R22 SERVICE BULLETIN SB-105

SUBJECT: Fuel Shut-Off Valve Replacement

ROTORCRAFT AFFECTED: R22-series helicopters S/N 0002 thru 4271.

FIGURE 1

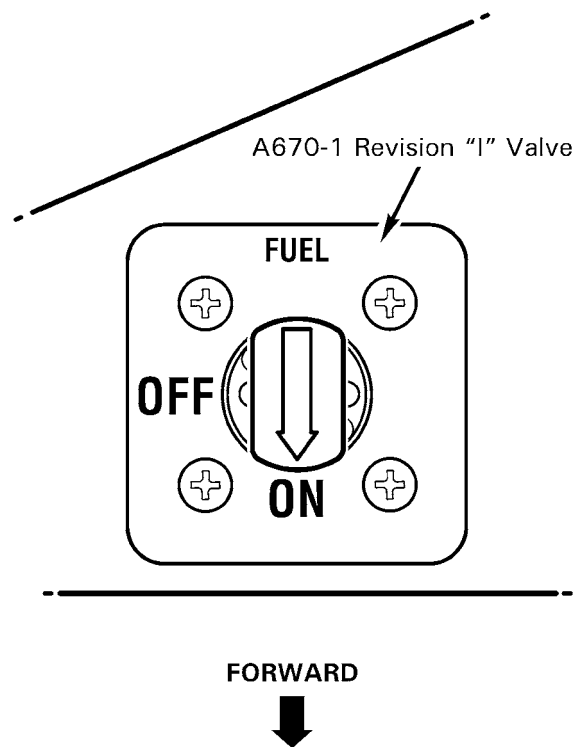
BACKGROUND: An accident occurred when a passenger moved a lever-handle fuel valve to the OFF position just before takeoff. New fuel valves are spring loaded to the ON position and have a small actuating handle to prevent inadvertent fuel shut-off. This bulletin requires replacing lever-handle valves with A670-1 revision I (or subsequent) valves.

1. Refer to Figure 1. If A670-1 revision I (or subsequent) fuel valve is installed, the requirements of this bulletin have been met and no further action is required.
2. Order one A670-1 revision I (or subsequent) fuel valve; order B270-6 sealant and one MS27039C1-06 screw as required.
3. Defuel helicopter per R22 Maintenance Manual (MM) § 1.150.
4. Remove left side skirt and panel. Remove left seat back.
5. Refer to IPC Figure 12-1. If applicable, remove sealant from 2700-06-06 bulkhead union and where it may be sealed at the top of the firewall. Vacuum debris and thoroughly clean firewall.
6. Inside engine compartment, loosen B-nut securing A726-1 line assembly to bulkhead union. Remove bulkhead union's nut and washer.

11. Apply B270-6 sealant sparingly to tapered pipe threads of elbow (do not apply sealant to first thread). Clamp A670-1 revision I (or subsequent) fuel valve in padded vise and install elbow with attached bulkhead union in valve outlet (arrow on handle points to outlet when in OFF position). Standard torque elbow per MM § 1.320 and align fitting as required.

12. Apply B270-6 sealant sparingly to tapered pipe threads of other elbow (do not apply sealant to first thread). Install tapered-thread side of elbow in fuel valve inlet. Standard torque elbow per MM § 1.320 and align fitting as required.

13. Position assembled valve and bulkhead union with NAS1149F0932P washer through firewall, and position seat back for installation. As required, install NAS1149F0932P washers between bulkhead union nut and the top of the firewall to position valve at correct height.
